This report has been prepared for the applicant in support of a s127 application in relation to a proposed variation of consent conditions 1, 2 and 16 associated with 2250376-RMALUC, which relates to the approved plans prepared by Lindholm Design for the dwelling extension and new boat shed at 55 Kingfisher Drive, Kerikeri. A swimming pool and associated paved area was approved as part of 2250376-RMALUC, which is now proposed to be relocated southeast of the dwelling.

PROPOSED EXTENSION TO EXISTING DWELLING & NEW BOATSHED FOR IAN and VICKI SMITH AT 55 KINGFISHER DRIVE, KERIKERI LOT 2 DP 311542 & LOT 4 317854

Re: I & V Smith – Revised Pool Location - 55 Kingfisher Drive, Kerikeri

Figure 2 – Location of swimming pool and paved area subject to this application (Source: Lindholm Design)

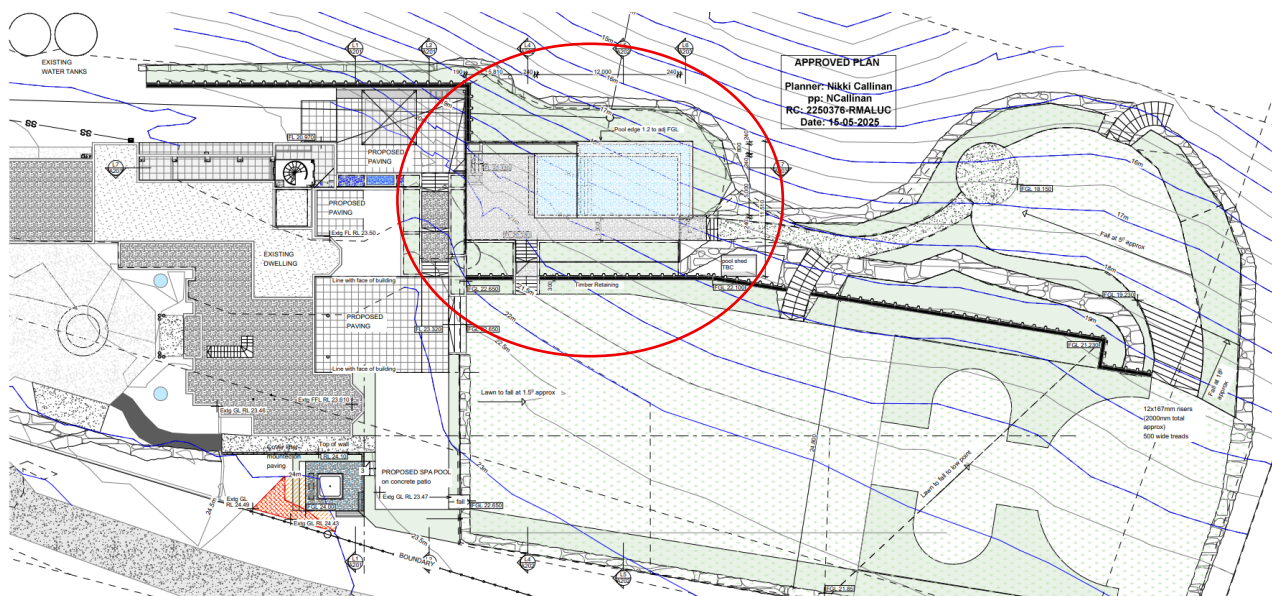
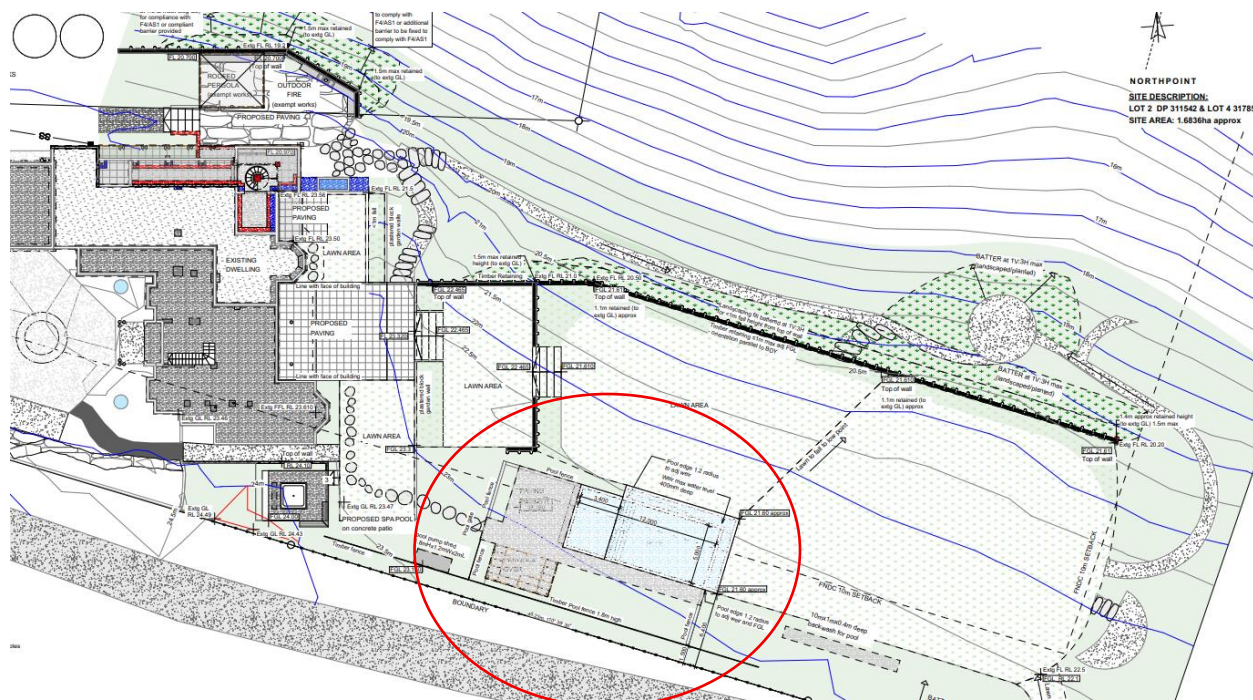
- Condition 1: The location of the swimming pool and associated paved area has been changed. The design change is considered to result in breaches which are within the confines of the original application.
- Conditions 2 and 16: A revised Visual Amenity Plan relative to the swimming pool area and associated Visual Amenity addendum have been prepared to address and effects associated with the relocated swimming pool and associated paved area.

The relocation of the swimming pool and associated paved area does not change the quantum of impermeable surface for the site. There is a minimal increase in earthworks volume of 10m³, which

A setback from boundaries breach remains on the southern boundary. The new location of the swimming pool and associated paved area incur a breach associated with the pergola, as this is the only component of the facility that is considered to be a building or structure as per the definition in the Operative Far North District Plan (**ODP**). An updated Visual Amenity Plan and Visual Amenity addendum, prepared by Hawthorn Landscape Architects has been prepared to assess the effects of the new swimming pool location. The Amenity report concludes that the revised proposal will not visually dominate the view from any adjoining properties or from the private road to the south of the applicant's property. There will be no adverse effects upon the privacy, outlook and enjoyment of private open spaces on adjacent sites. Further, the proposed development is sensitive to the environment it is located within so that the potential adverse visual amenity and natural character effects are less than minor.

1. The activity shall be carried out in general accordance with the approved plans prepared by Lindholm Design, referenced Concept and Resource Consent, dated 25/03/2025, ~~drawing A00–A07, A101–A103, A102–A/B/C/D, A201–A203. And attached to this consent with the Council’s “Approved Stamp” affixed to it.~~

Approved plans prepared by Lindholm Design, referenced Concept and Resource Consent, dated 10/06/2025:

26.06.2025	
Pool Area - Revised Visual Amenity Plan Ian & Vicki Smith 55 kingfisher Drive, Kerikeri	
Scale	Drawn By
1:200 @ A3	Cad Design
Drawing #	Rev #
2.0	B

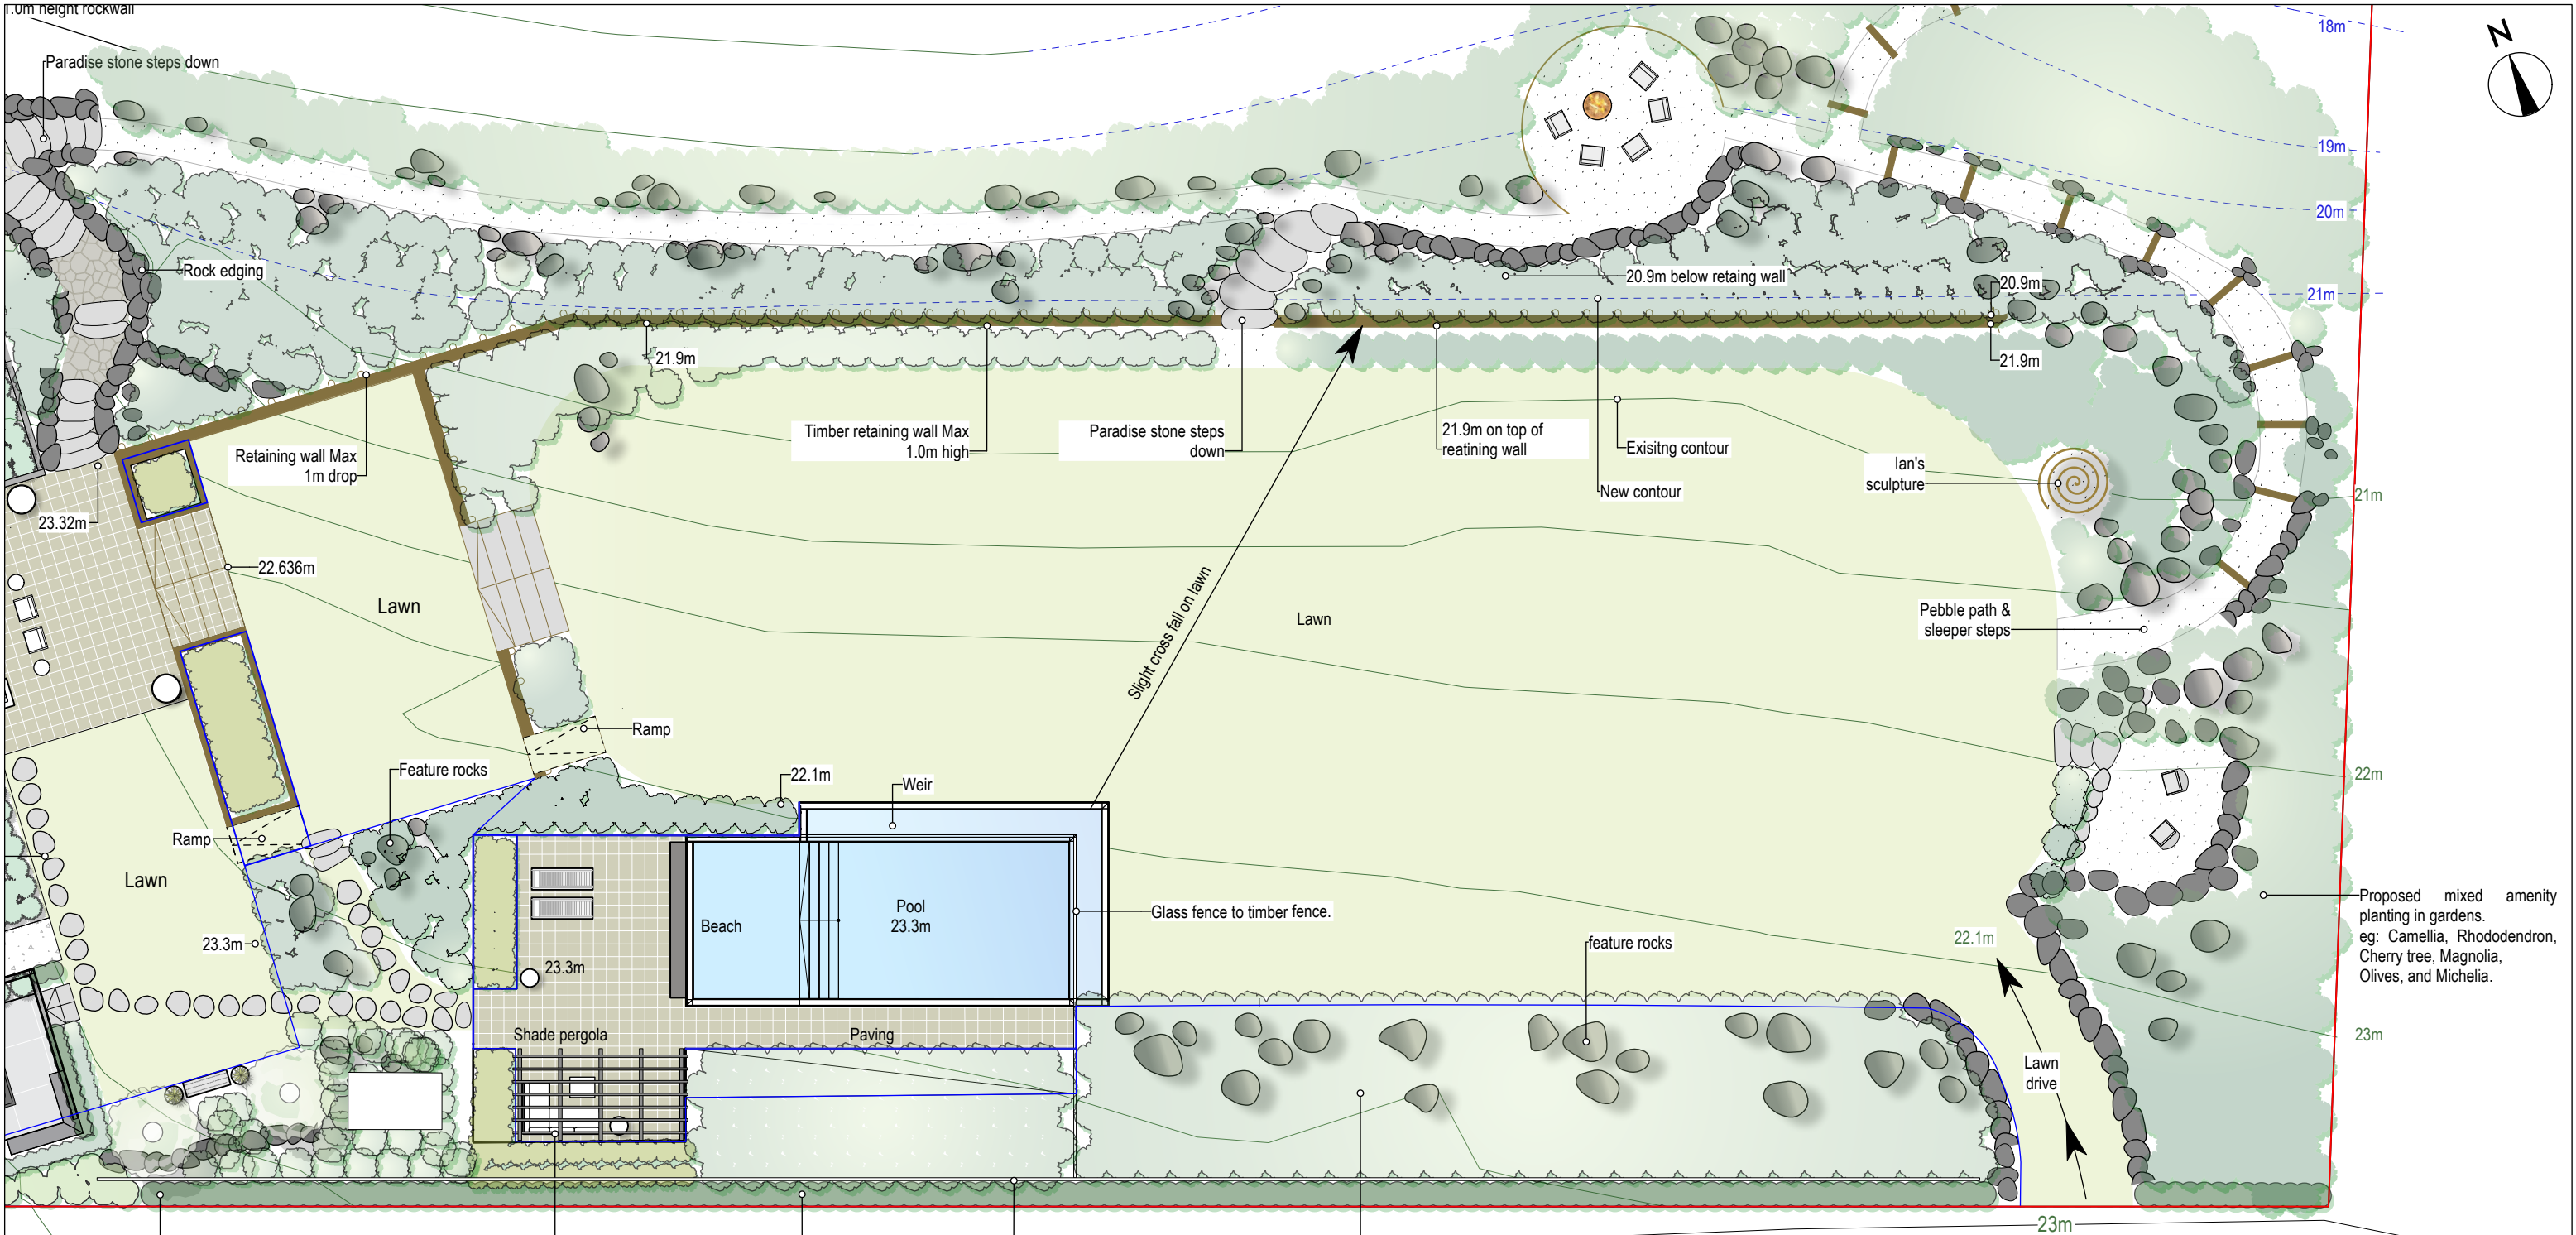
I have attached a revised Visual Amenity Landscape Plan that illustrates the new location and layout of the swimming pool area, associated paving, fencing and pergola. The integration landscape plantings located around the pool area and within the gardens are also detailed.

I have considered the visual amenity aspects relating to the revised proposal, specifically the siting, set back from the boundary and design of the timber pergola that is proposed to be located between the pool area and the southern boundary, adjacent to the private road.

A camellia hedge will be grown on the southern side of the timber fence to soften the view of it from the private road. Other landscaping will be located around the pool area and within the wider grounds as shown on the Visual Amenity Landscape Plan, these will integrate the proposal into the landscape.

Area – revised Visual Amenity Plan dated 26.06.2025 and the Visual Amenity addendum dated 30th June 2025.
